NONCONFORMANCE REPORT

C-02834-V

Unit Coder 2VM54A

Welded Connections of Structural Supports

DETAIL (2)

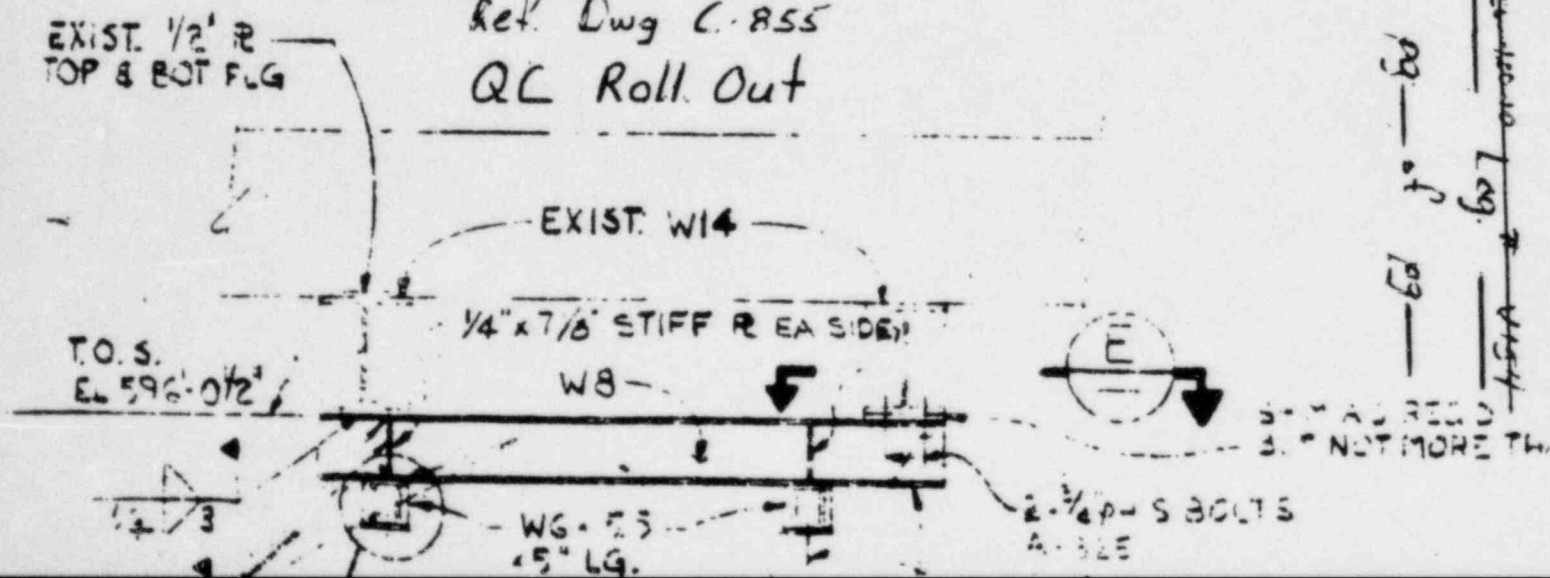
13 NONCONFORMANCE 1. Fillet weld sizes are not in accordance with the design requirements.

Item #1 Spec. C-304 para. 6.2.1.1 Minimum fillet weld size shall be the size specified on the Dwg. ... (Dwg C-855 rev.22 Oct. 2 Sec. B & Dwg. C-862 rev.22 Oct. 6)

QC Roll out NO SCALE
Structural Supports for Unit Cooler 2UM54A
Ref. Dwg. C-855

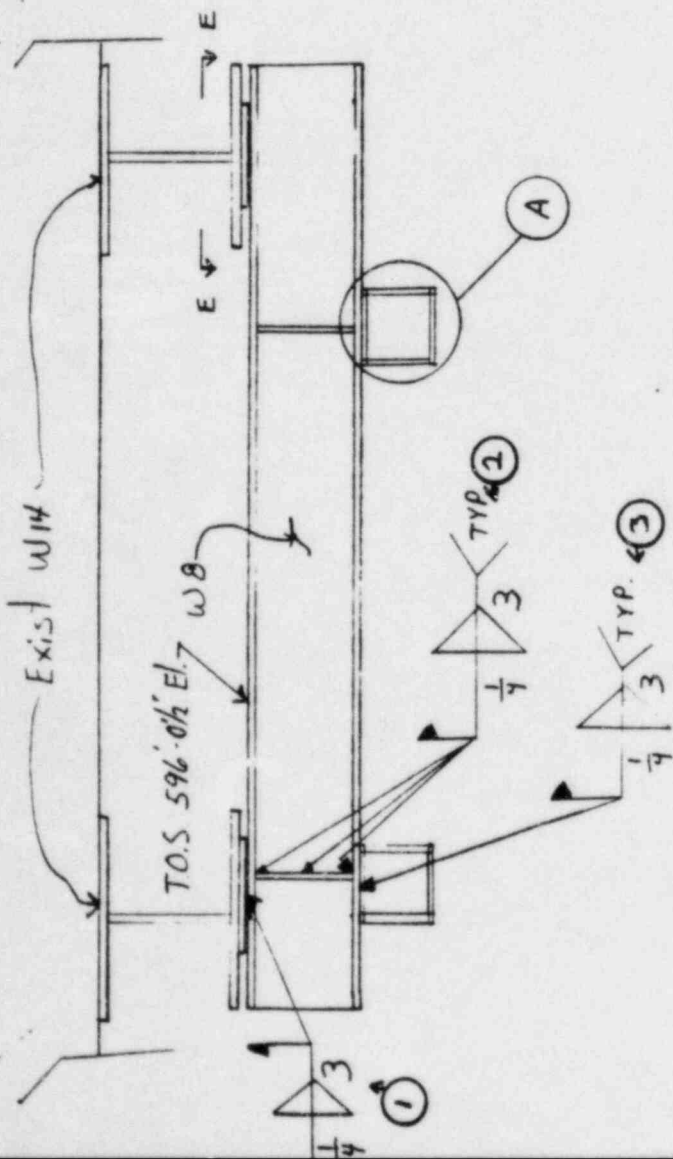
ABC,D Plan Locations
1,2,3,4,5 Individual Welds

N.S. Near Side (Looking North)
F.S. Far Side (Looking South)

2NS (TYP)

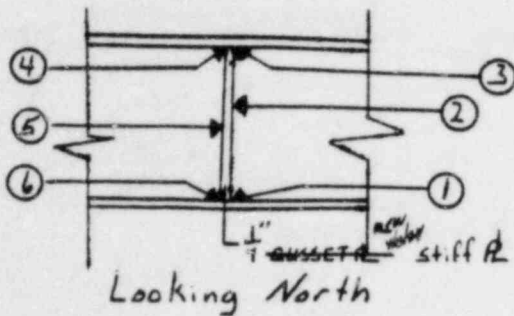
Notes: Undersize = 1 leg $\frac{3}{16}$ "
Insufficient Throat = $< \frac{1}{4} \geq \frac{3}{16}$ " *
* Fillet Gage Size
* Gouges in weld metal apparently caused by grinding.

Weld C2NS

Weld B2NS

1) Gouge in weld metal (G.W.M.) *
 $2 \frac{1}{4}$ " length $\frac{3}{32}$ to $\frac{1}{8}$ " Deep

2) $5 \frac{7}{8}$ " length
G.W.M. $4 \frac{3}{8}$ " length $\frac{3}{32}$ " Deep

4) G.W.M. $2 \frac{3}{8}$ " length $\frac{3}{32}$ " Deep

5) $5 \frac{7}{8}$ " Length
G.W.M. 4" length $\frac{1}{8}$ " Deep

6) G.W.M. $2 \frac{3}{8}$ " length $\frac{5}{32}$ " Deep

Weld A2NS

1) Insufficient Throat $\frac{1}{2}$ " \approx

2) $5 \frac{7}{8}$ " length
Insufficient Throat & Undersize 100%

3) Insufficient Throat 50% \approx
Undersize 100%

4) Undersize 100%

5) Undersize & Insufficient Throat 100%

6) Undersize 100%
Insufficient Throat 50% \approx

Weld O2NS

1) Undersize 25% \approx Insufficient Throat 80% \approx

2) Undersize & Insufficient Throat 100%

3) Insufficient Throat 50% \approx

4) Undersize 100% Insufficient Throat 25% \approx

5) Undersize 100% Insufficient Throat 10% \approx

2 FS (TYP)

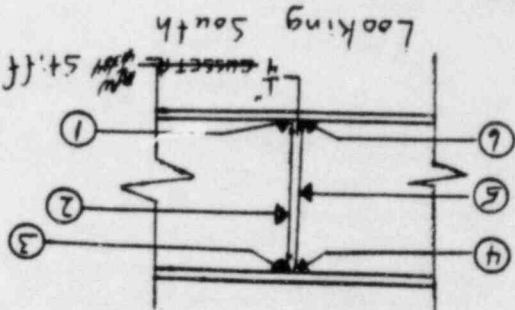
Weld A2FS

1) Under size & Insufficient Throat 90% ≈

Under size 90% ≈ Insufficient Throat 1" ≈

3) Under size 60% ≈ Insufficient Throat 1" ≈

4) Under size 25% ≈ Insufficient Throat 1/2" ≈

5) Under size 90% ≈ Insufficient Throat 75% ≈
Length 5 1/2"

6) Under size & Insufficient Throat 50% ≈

1) Under size & Insufficient Throat 100% ≈

2) 5 9/16" length, Under size 100% ≈

4) Crater Not filled to full cross section of weld

5) Length 5 1/8" Insufficient Throat & Under size 25% ≈

6) Insufficient Throat & Under size 90% ≈

4) + 3) Base metal seam runs up to the toe of each weld.

Notes: Under size = 1 leg 5/16"
Insufficient Throat = 1/4" - 3/8"
* Fillet Gage & size

Dug L-855 re 22 calls for these stiff Rs to be on the South side of the Wlx 15.85

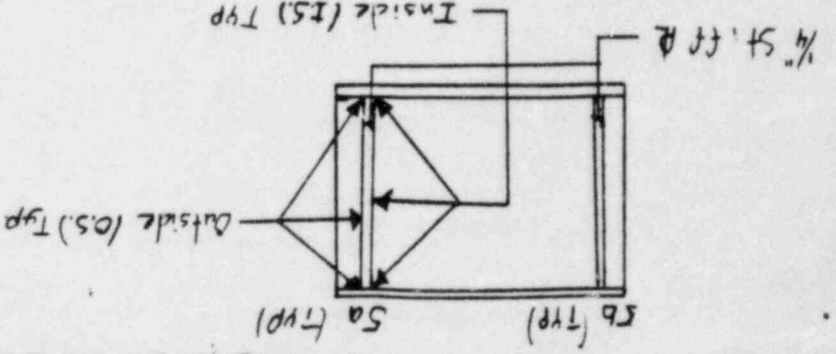
The opposite exists in the field.

O.S. Undersize & Insufficient Throat 100%
I.S. Undersize 80% = Insufficient Throat 25%

O.S. Undersize & Insufficient Throat 100%
I.S. Undersize 100% Insufficient Throat 10%

O.S. Undersize 25% = Insufficient Throat 25%
I.S. Undersize & Insufficient Throat 40%

Lack of Fusion & Slag Included 1/2" length
Bottom Corner at web & stiff R

O.S. Undersize 100% Insufficient Throat 95%
I.S. Undersize & Insufficient Throat 50%

O.S. Undersize 100% Insufficient Throat 40%
I.S. Undersize 100% Insufficient Throat 50%

O.S. Undersize & Insufficient Throat 100%
I.S. Undersize 80%

O.S. Undersize & Insufficient Throat 100%
I.S. Undersize 100% Insufficient Throat 10%

O.S. Undersize 90%
I.S. Undersize & Insufficient Throat 80%
